**85 HARRINGTON STREET,
THE ROCKS**

**RESPONSE TO
SUBMISSIONS**

9 AUGUST 2017
FINAL REPORT
PREPARED FOR GOLDEN AGE & HANNA THE ROCKS

Figure 1 – Amended DA Design photomontage looking south along Gloucester Street

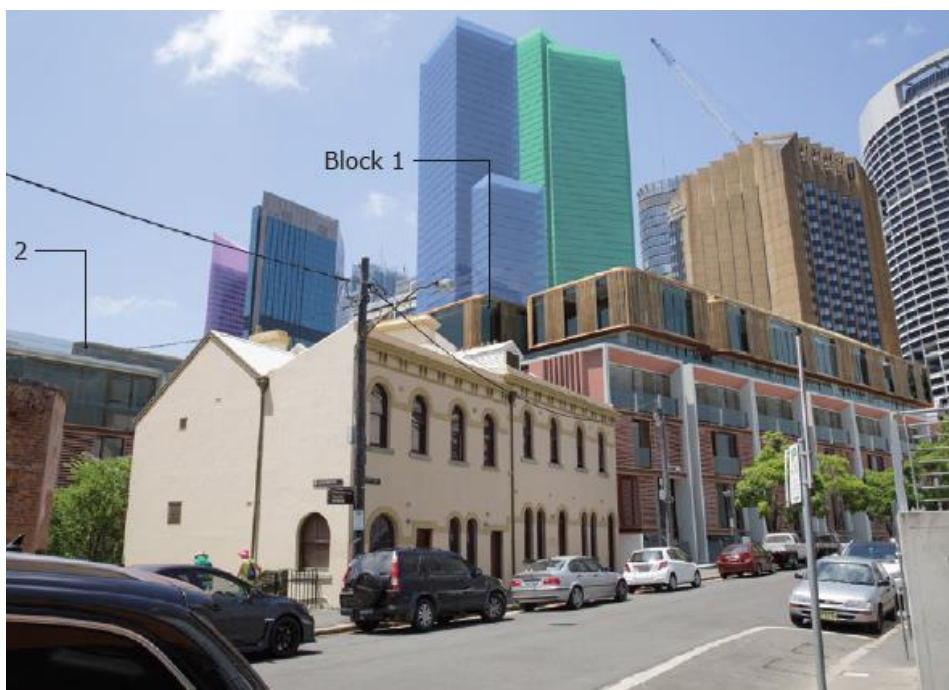
- **Height of Block 1 is inconsistent with the opposite building in the streetscape (on Harrington Street), Gloucester Street and the Bakers Terraces and creates an inequitable outcome and precedent to other properties** – As described in further detail in Section 3 of this report, the proposed amendments to the application will reduce the overall height of Block 1 by 3.9m and create a more consistent scale to the built form on the eastern side of Harrington Street. This is shown in Figure 1 below.

In addition, the amended design provides a parapet height and setbacks that align with the parapets of the built form on the eastern side of Harrington Street.

With regard to Gloucester Street, as discussed in Section 3 of this report, the proposed height reduction, setbacks and attention to the facades now provides a much more contextual form to The Bakers Terraces and streetscape. The photomontage below provides a contextual overview of how the proposal aligns with the horizontal and vertical elements of the Bakers Terraces in a positive manner.

Figure 3 – Operable shutters and upper level recess on the northern elevation adjacent to The Rendezvous Hotel to minimise overlooking

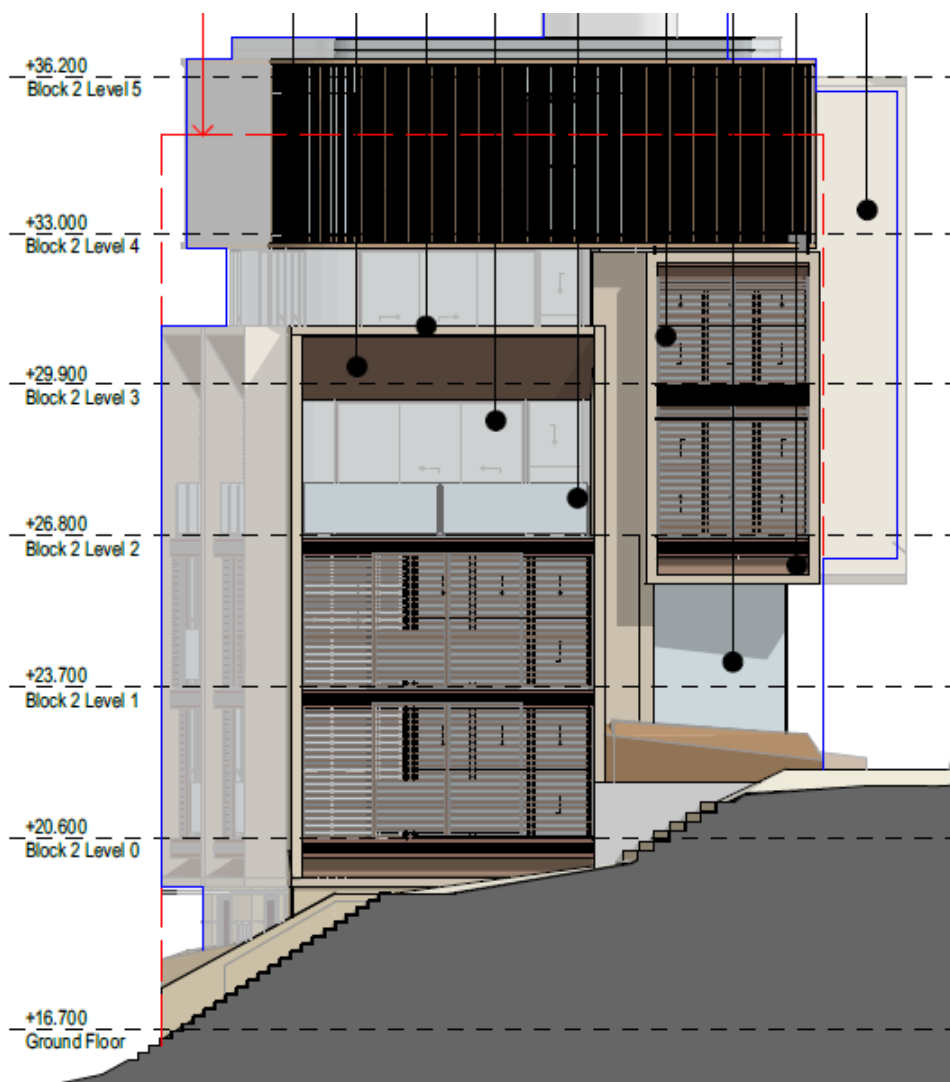
In terms of the site's immediate neighbour to the north (The Rendezvous Hotel on Harrington Street), we note that the leaseholders of this site (Far East Land Australia) have queried the building separation adjacent to their property. Both The Rendezvous Hotel and 85 Harrington Street (existing) are both built to the boundary of Cumberland Stairs.

The through site link stairs between the two sites vary in width from 3650 (western entry) to 6260mm (eastern entry). The walls fronting this through site link are carefully articulated to ensure privacy and screening. Primarily, apartments in this zone are oriented away from the stairs other than those which face into the new courtyard. The average dimension between Block 2 and The Rendezvous Hotel is over 6m and has 4-5 storeys of residential use over stepped terrain.

In accordance with the ADG, development up to 4 storeys requires a minimum separation of 6m (non-habitable to non-habitable rooms), 9m (non-habitable to habitable rooms) or 12m (habitable to habitable rooms). 5-8 stories requires a minimum separation of 9m (non-habitable to non-habitable rooms), 12m (non-habitable to habitable rooms) or 18m (habitable to habitable rooms). Therefore, as the proposal is providing 5 stories adjacent to the northern boundary, the ADG suggests that the first 4 floors need to be 6-12m, and the fifth floor needs to be setback 9-18m from the adjacent property.

The Rendezvous Hotel has some side windows adjacent to the Cumberland Stairs, however these appear as secondary windows, and rooms with balconies face Harrington Street. The proposed apartments will provide privacy screening which will reduce the opportunity for overlooking. The northern elevation is shown in the figure on the following page.

Figure 4 – Reduced parapet height along Gloucester Street (Original DA left, amended DA right)

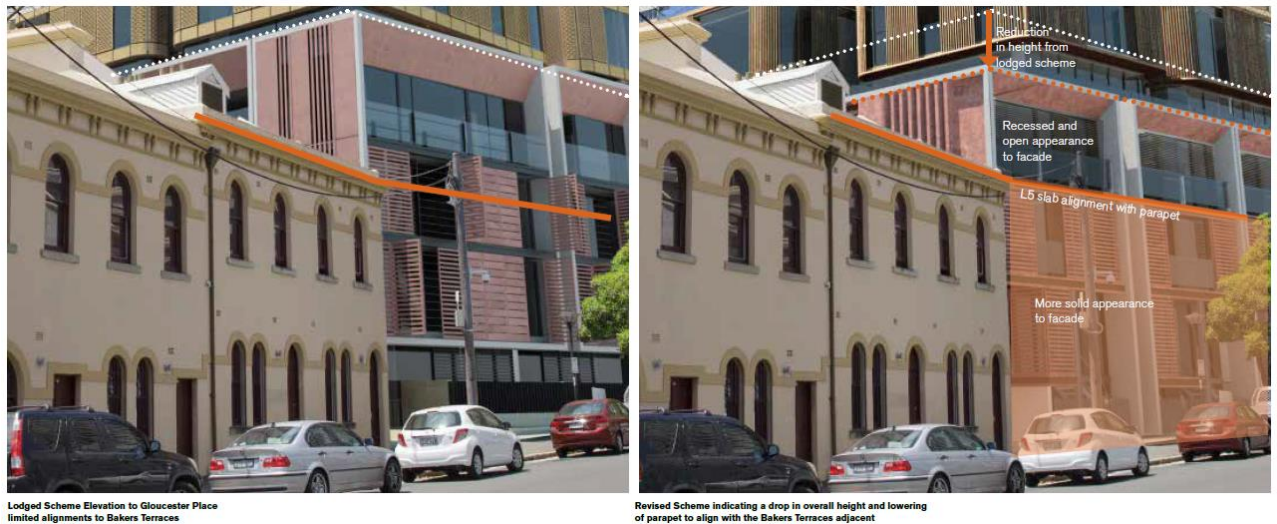
The Department requested that further consideration be given to the height, scale and massing of 'Block 1' to provide a more "sympathetic relationship" to the Bakers Terraces, Susannah place terrace and Gloucester Street terraces. The letter also clarified that the design response should also consider opportunities for increased setbacks to surrounding heritage items.

The height of Block 1 and relationship to the heritage terraces on Gloucester Street was a common theme in the submissions by the City of Sydney, NSW Heritage Branch and Professor Peter Webber, as discussed in Section 2 of this report. A range of design amendments have been proposed in response to this feedback, and is discussed in further detail below.

- **Reduction in the parapet height of Block 1 by 3.9m.** The commercial office element which previously flanked the southern end of the building has been relocated to Level 1 of the built form which has allowed for the creation of a more coherent built form and residential floor plate. This amendment has reduced the scale of the proposal, when viewed from in and around the site. Accordingly, the amendment sought to the SCRA for Block 1 has been updated to reflect this key change. The images on the following page provide an overview of the reduced building height and the positive relationship this has with the immediate and surrounding context of the site.

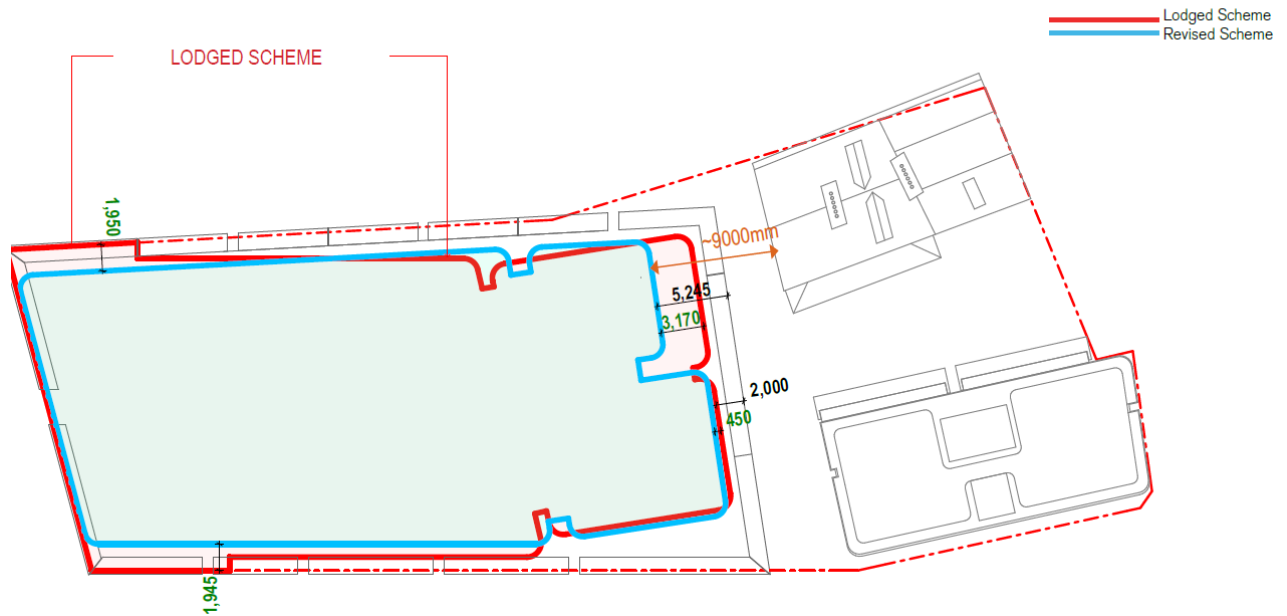
- **Setbacks of Block 1** – In addition to the amended building height, the proposed amendments provide increased setbacks on Block 1 to create a better transition to the heritage terraces on Gloucester Street. See Section 3 of this report for further detail.

- **Increased building setbacks of Levels 6 to 8 of Block 1 to create a better transition to the heritage terraces.**

In addition to the amended building height, the proposed amendments provide increased setbacks on Block 1 to create a better transition to the heritage terraces on Gloucester Street. The red dotted line below provides the previous DA envelope.
